SERVICE LETTER SL20 65-45100

Part/Assembly #: 65-45100

Float Model Affected: Aerocet Model 6650 Floats, Kodiak Aircraft

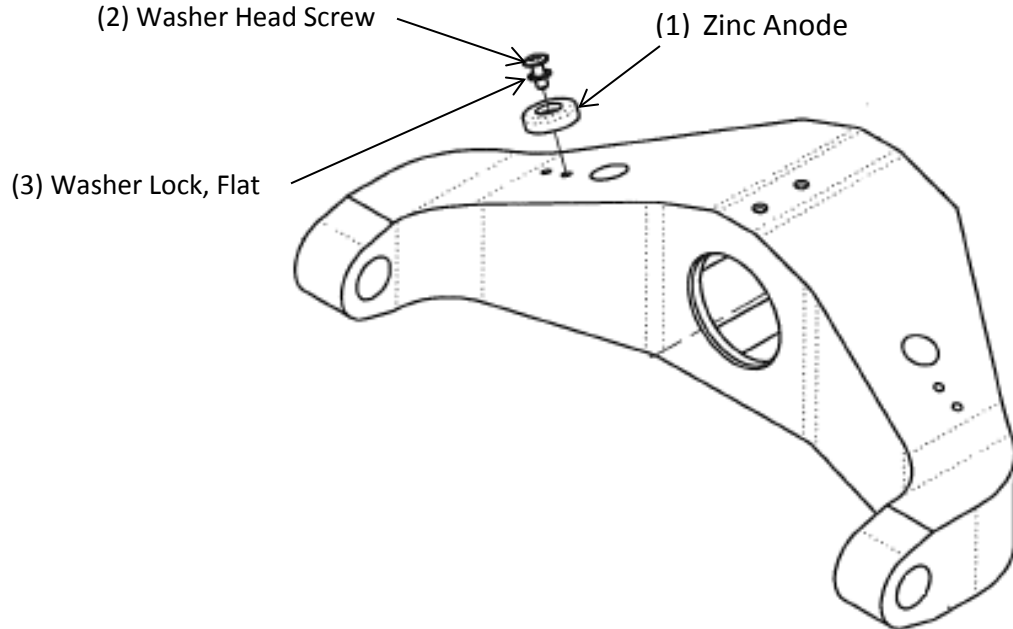
Reason for Change: To Increase anodic protections in the 6650 float gear.

Corrective Action: Optional anode installation.

1. Add optional installation of 35A-40120 Zinc Anode to unused, inboard #10-32 threaded hole.

2. Assure continuity between anode and assembly.
3. Chase threads if necessary to remove possible insulating debris or anodizing
4. Recommend filling the remaining, unused #10-32 outboard hole with Sika-Flex 292 or equivalent marine grade urethane sealant.
5. Apply Loctite Thread blocker Blue 242 to #10 fasteners upon installation.
